# Access Compliance Report

## Public Rights-of-Way

Intersection ID: 19049	Main Street: BRAEBURN_RD	Cross Street: ROCKY_FALLS_RD	Location: NE
ADA ID: 4251EEF7AEED	Ramp Type: BlendTrans2	Initial Pass/Fail: Fail	Overall Compliance: No
		Severity Score: 12.5

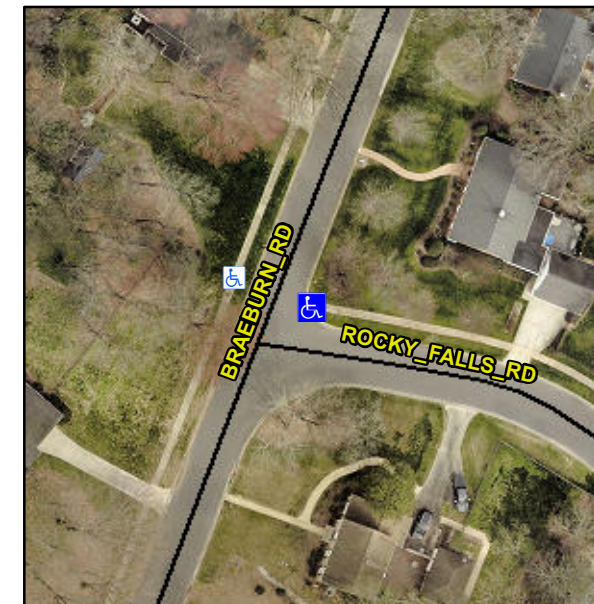
**Not Found, R304.5.3**

Compliance	Description	Data	Compliance	Description	Data
N/A	Ramp Length (in)	80.0	Yes	BlendTrans Slope (%)	1.2
Yes	Ramp Width (in)	48.0	No	BlendTrans XSlope (%)	5.2
N/A	Flare Type LT	N/A	N/A	Flare Type RT	N/A
N/A	Flare Slope LT (%)	N/A	N/A	Flare Slope RT (%)	N/A
N/A	Flare Traversable LT?	N/A	N/A	Flare Traversable RT?	N/A
N/A	Landing Length (in)	N/A	N/A	DWS Provided?	N/A
N/A	Landing Width (in)	N/A	N/A	DWS Contrast?	N/A
N/A	Landing Slope (%)	N/A	N/A	DWS Length (in)	N/A
N/A	Landing X Slope (%)	N/A	N/A	DWS Full Width?	N/A
N/A	Landing Curb? (Y/N)	N/A	N/A	DWS Offset (in)	N/A
N/A	Shared Landing?	N/A			
N/A	Gutter Ponding?	N/A	N/A	Gutter Slope (%)	N/A
N/A	Gutter Lip Ht (in)	N/A	N/A	Gutter X Slope (%)	N/A
N/A	Painted X Walk1?	No	N/A	Painted X Walk2?	No
	X Walk 1 Direction	To W		X Walk 2 Direction	To S
	X Walk 1 Width (in)	N/A		X Walk 2 Width (in)	N/A
	X Walk 1 Slope (%)	2.7		X Walk 2 Slope (%)	3.9
	X Walk 1 X Slope (%)	3.4		X Walk 2 X Slope (%)	3.3

**Remove & Replace Curb Ramp With Two New Directional Ramps or Equivalent.**
